Tx Equalizer Coefficient issues

Andre Szczepanek

Texas Instruments

Comment #64

Changes

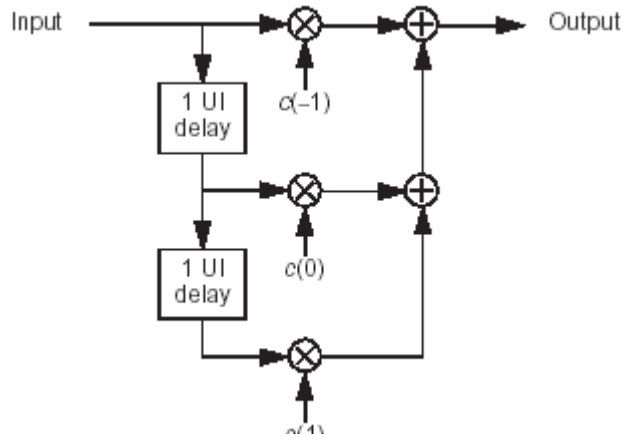
- The changes recommended in healey_01_0905 to clean up the transmitter waveform tests removed the constant V_{pk} requirement.
 - Rather than just removing a requirement on non-constant V_{pk} transmitters it made constant V_{pk} transmitters non-compliant
 - The bulk of this presentation was on improving the test methodology
 - In this context, I don't believe the practical impact of removing V_{pk} was realized.
 - It wasn't discussed
 - I have voted NO on the ballot based on this change to ensure that we discuss it now
- There may be practical reasons to limit ourselves to one style of equalizer
 - Is there an equalizer training algorithm that will work with both ?
 - Maintaining constant V_{pk} in the training commands will work

Measurements are not independent

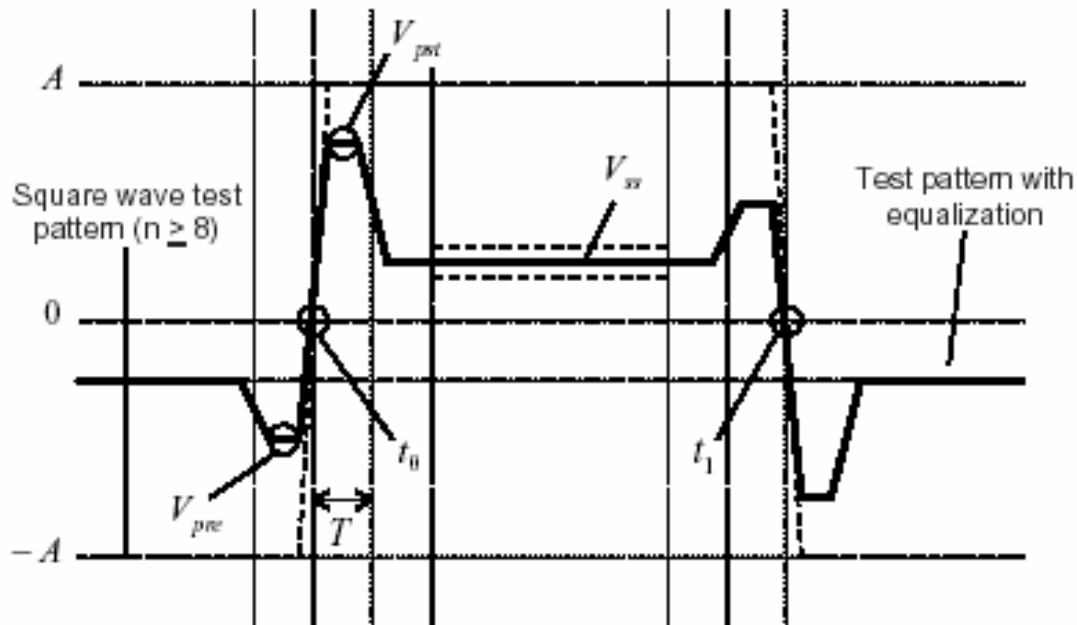
- $V_{pre} = +c(-1) - c(0) - c(+1)$
- $V_{pst} = +c(-1) + c(0) - c(+1)$
- $V_{ss} = +c(-1) + c(0) + c(+1)$
- $A = V_{pst} - V_{pre} - V_{ss}$
 $= -c(-1) + c(0) - c(+1)$

- Note $c(-1)$ & $c(+1)$ are always negative !
- So $A = |c(-1)| + |c(0)| + |c(+1)|$
